Administrative Approval Action

Case File / Name: ASR-0010-2024
Lake Haven Affordable Housing Development - ASR

The plan proposes a senior affordable housing project with associated infrastructure and site improvements. Fifty-six (56) apartment units will be located in a 64,639 square foot 3-story building accessible from Lake Woodard Drive and Trawick Road via two existing access easements. Eighty-one (81) vehicular parking spaces are proposed along with 16 bicycle parking spaces (4 short-term and 12 long-term). The project is utilizing the base standards for mixed-use district and not the frequent transit development option.

City Administration finds that this request, with the below conditions of approval being met, conforms to the Unified Development Ordinance. This approval is based on a preliminary plan dated June 6, 2024 by EVERGREEN CONSTRUCTION - TIM MORGAN.

LIGHTING PLAN

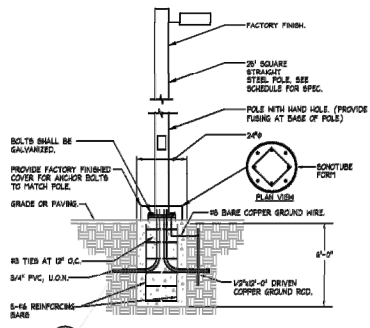
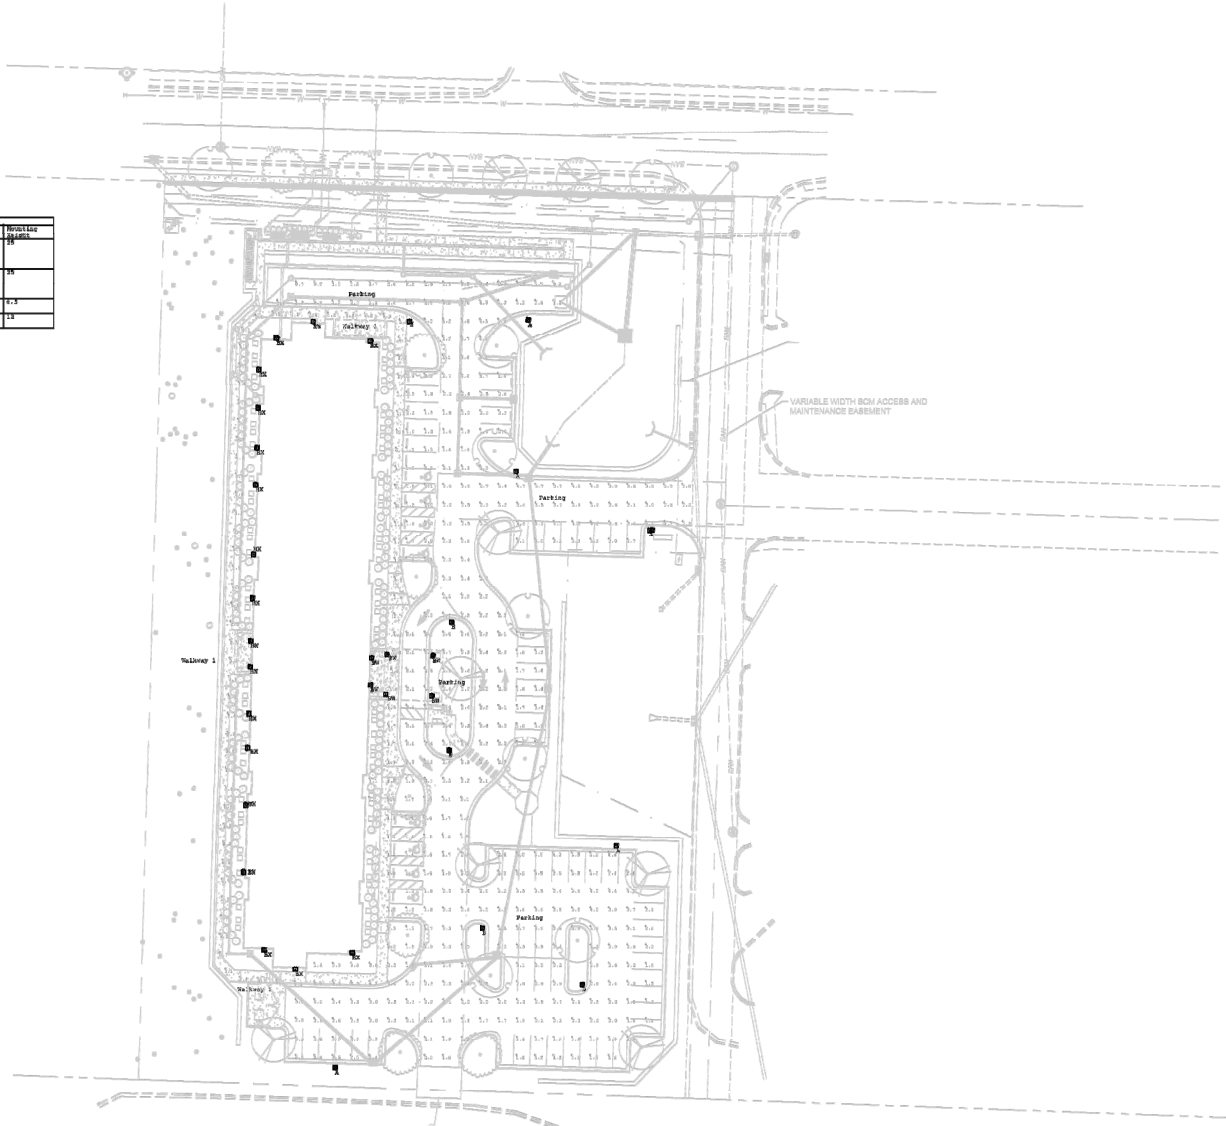
2. Prior to approval, plan shall show compliance with Section 7.4, Lighting. Specifically, on Sheet C5.1, you need to identify all applicable components of the proposed fixtures not selected on the cut sheets, especially for fixtures Type A and Type B. These include mounting height, pole, wattage, etc. and even color.

3. Prior to approval, plan shall show compliance with UDO Section 7.4, Lighting. Specifically, per Section 7.4.4, the maximum light level of any fixture cannot exceed 2.0 footcandles measured at the right-of-way line of a street. The light array should show the light levels to the property lines, and along Lake Woodard, to the right-of-way line to show compliance with this section.
